PROJECT: QUICK LANE GORTON

DRAWING TITLE: PROPOSED LAYOUT

DRAWN BY: J.BENNETT		DATE: 17/09/20	
APPROVED:		DATE:	
DWG NUMBER: QLG-001	REV:C	SCALE: 1:50	A1

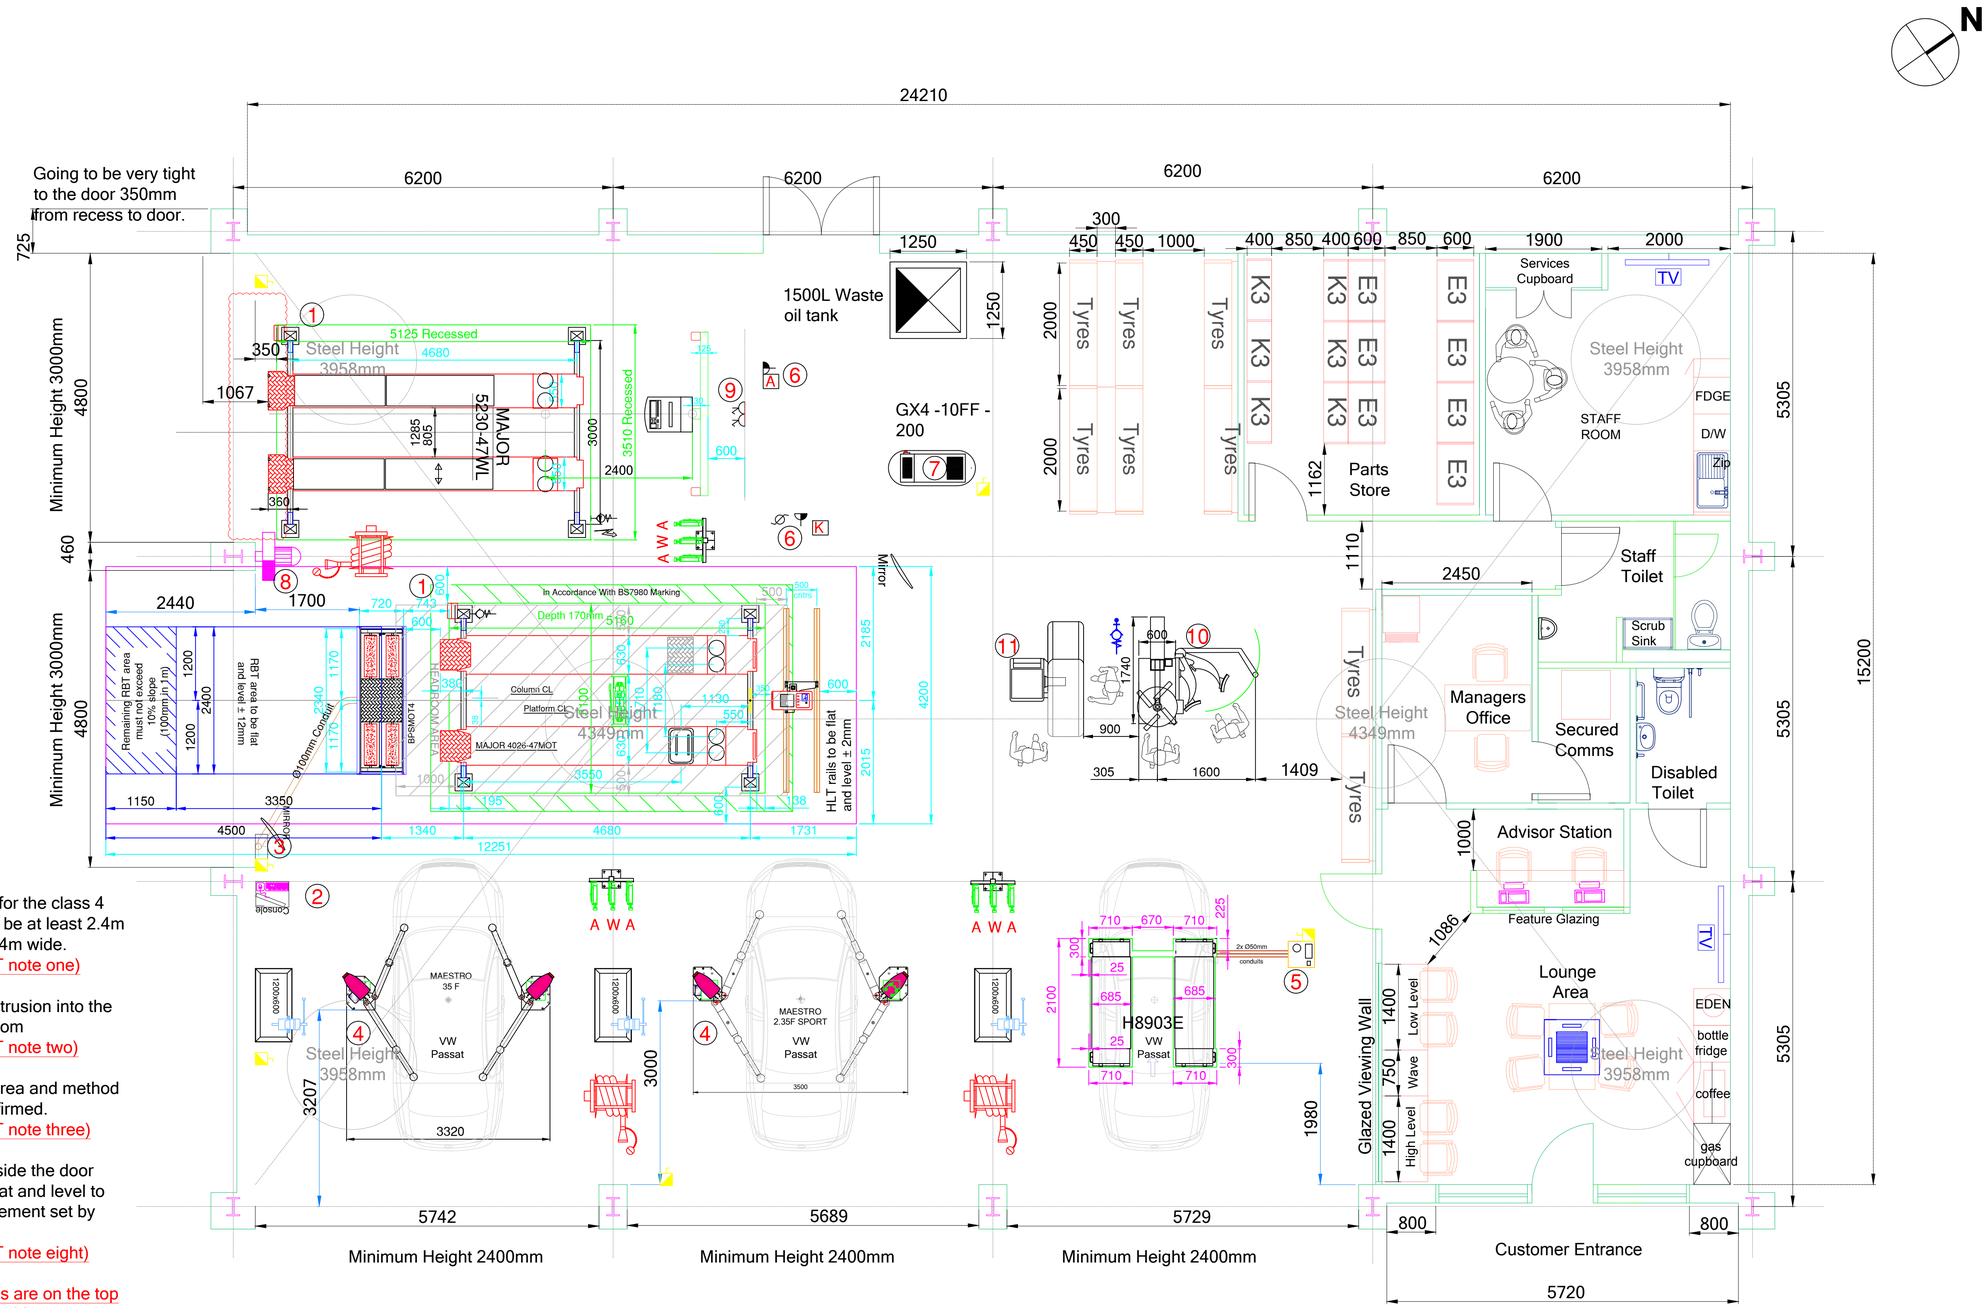
The door for the class 4 lane must be at least 2.4m high by 2.4m wide.
(See MOT note one)

680mm intrusion into the lift headroom
(See MOT note two)

Viewing area and method to be confirmed.
(See MOT note three)

Area out side the door must be flat and level to the requirement set by DVSA
(See MOT note eight)
